***EXPEDITED***  
**MONTGOMERY COUNTY HISTORIC PRESERVATION COMMISSION**  
**STAFF REPORT**

<b>Address:</b>	26038 Frederick Road, Clarksburg	<b>Meeting Date:</b>	8/14/2019
<b>Resource:</b>	Primary (1810-1890) Resource (Hyattstown Historic District)	<b>Report Date:</b>	8/7/2019
<b>Applicant:</b>	Tobias Herman and Kristine Lui	<b>Public Notice:</b>	7/31/2019
<b>Review:</b>	HAWP	<b>Tax Credit:</b>	Yes
<b>Case Number:</b>	10/59-19A	<b>Staff:</b>	Michael Kyne
<b>PROPOSAL:</b>	Roof replacement

**PROPOSAL:**

*Fig. 2: Existing roofing materials (top, black text) and proposed roofing materials (bottom, red text).*

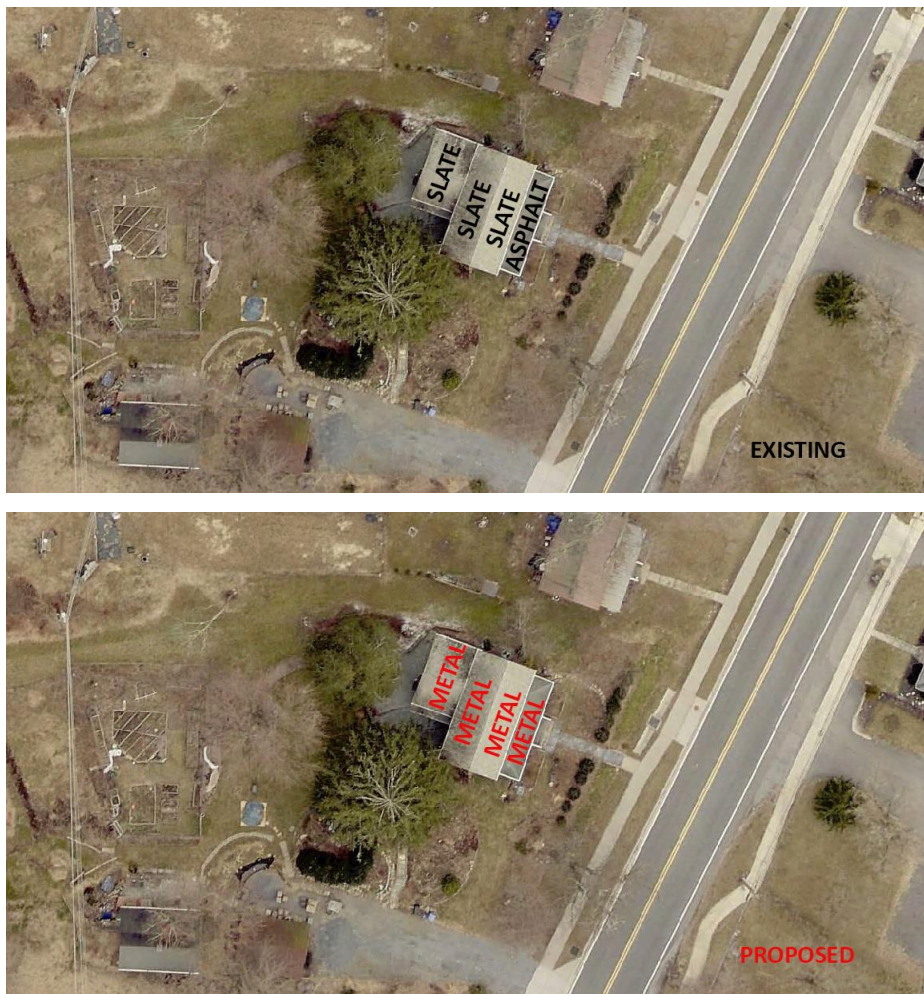
The applicants propose to replace the existing slate and asphalt roofing with standing seam metal roofing at the subject property. The proposed standing seam metal roofing will have 1" high mechanically locked vertical seams; and, in lieu of ridge caps, the ridges will be seamed to match the vertical seams.

The applicants have stated that the existing slate roofing tiles and nails are failing, requiring replacement. Additionally, the slope of the existing rear addition is 2:12, which is below the standard roof pitch for slate (with the standard being 4:12, according to the guidelines established by the Slate Roof Contractors Association of North America). At 4.5/12, the slope of the main house roof is just above standard. Standing seam metal roofs are a prevalent feature in the Hyattstown Historic District and standing seam roofing is an appropriate and compatible material for the subject property.

Illustration #3  
26038 Frederick Rd  
Finished View

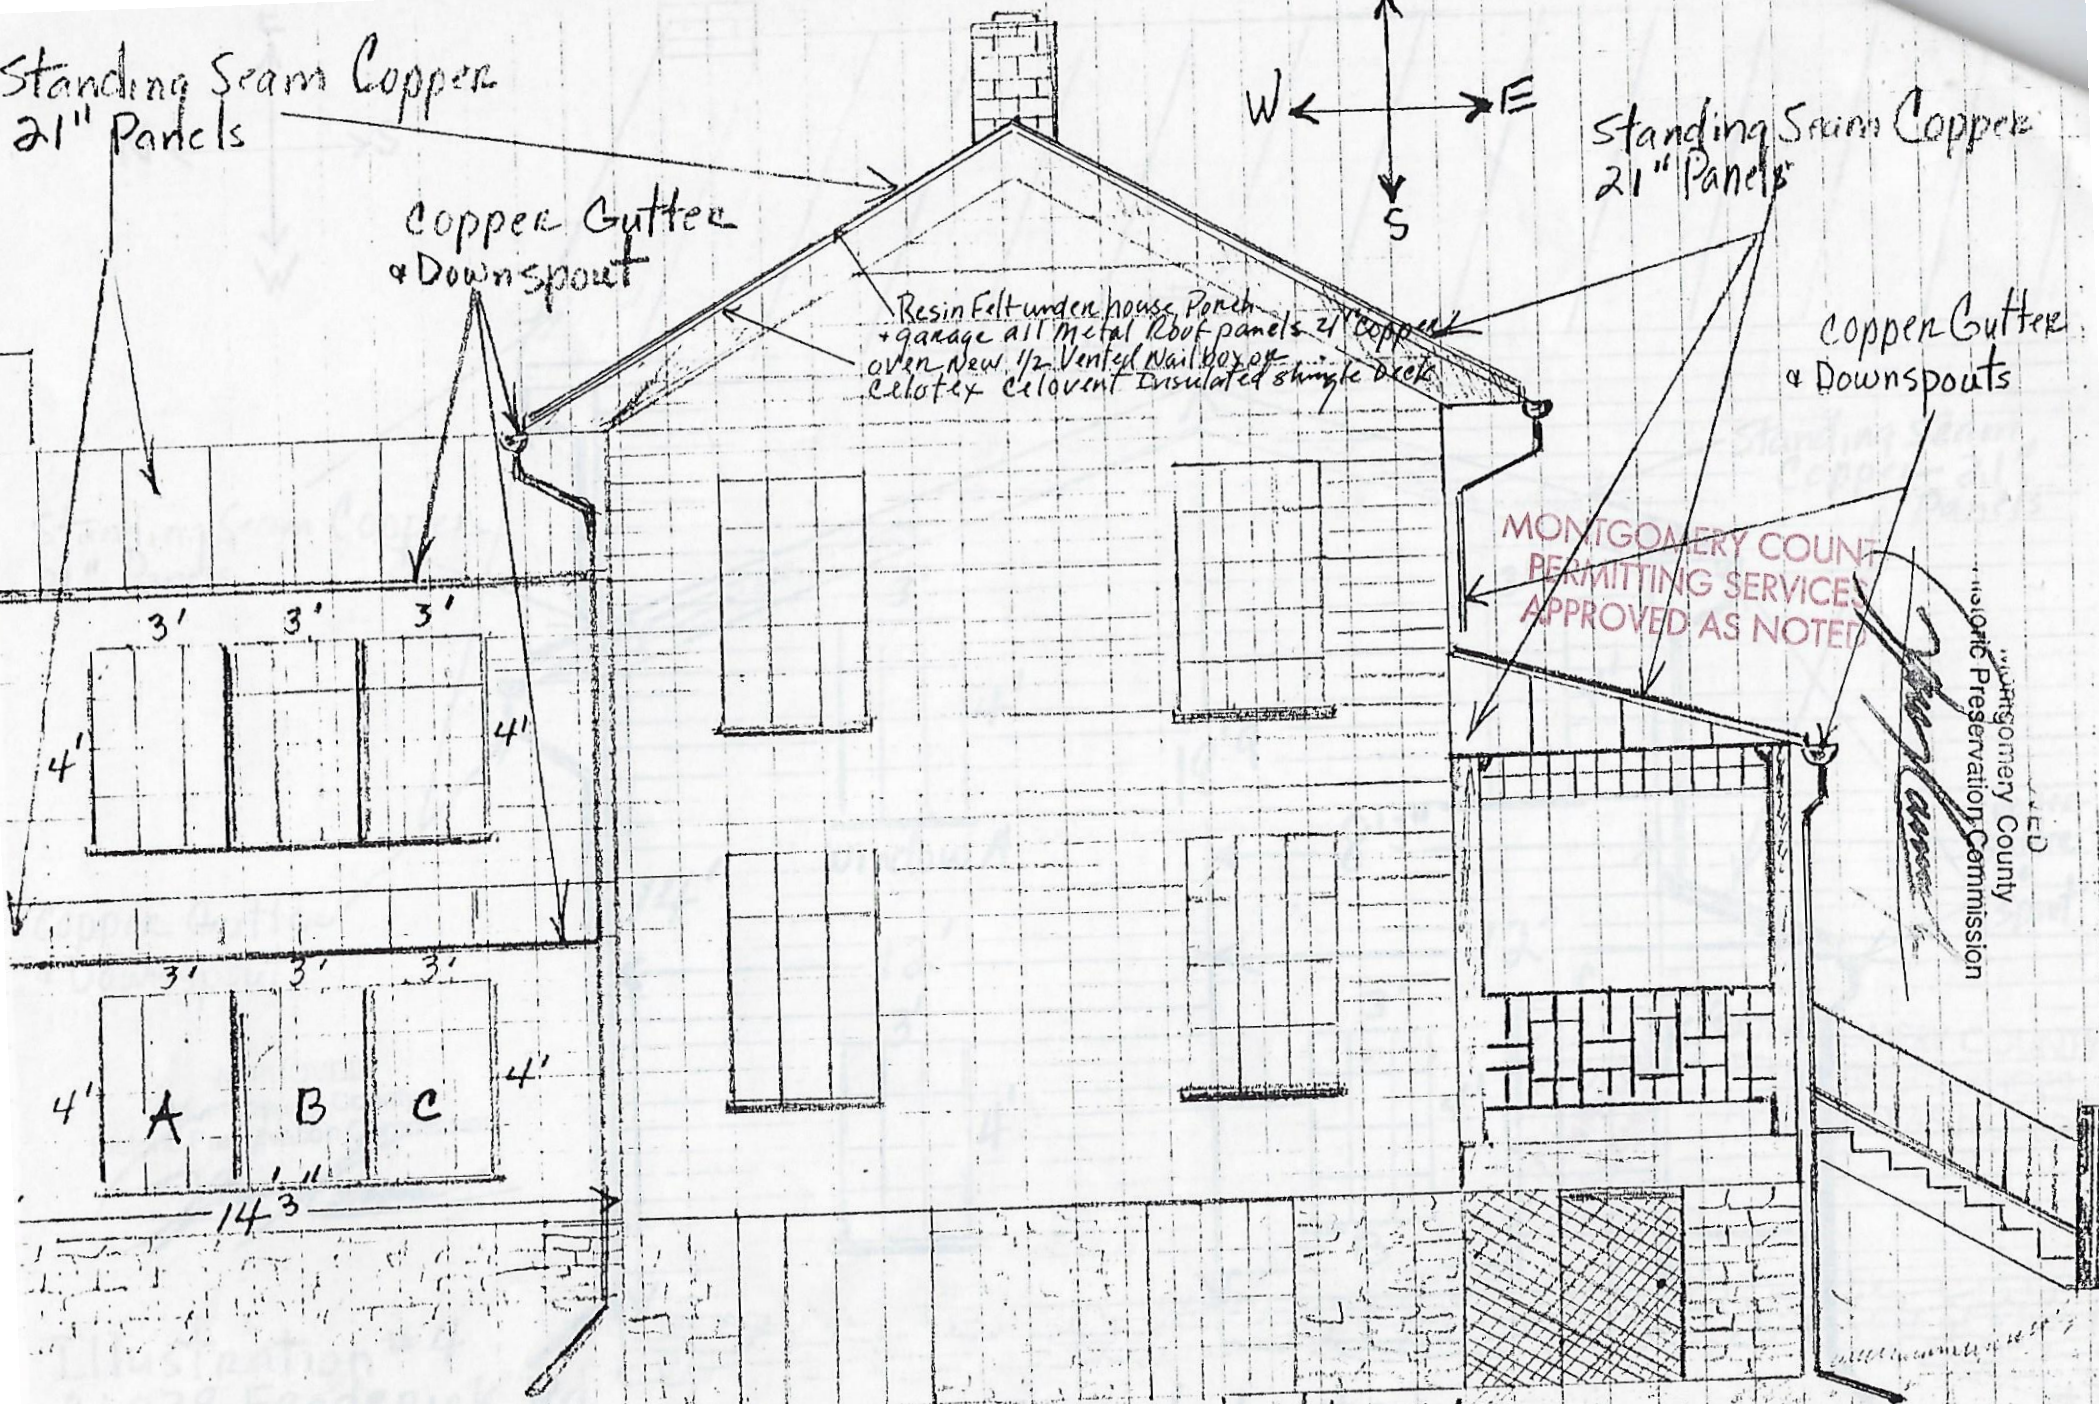
- Changes From Illustration #1
- 1) Replace Roof Gutters
  - 2) Restructure Porch wall base in Fieldstone
  - 3) Enclose Porch with Matched Siding
  - 4) Add Windows A, B, C
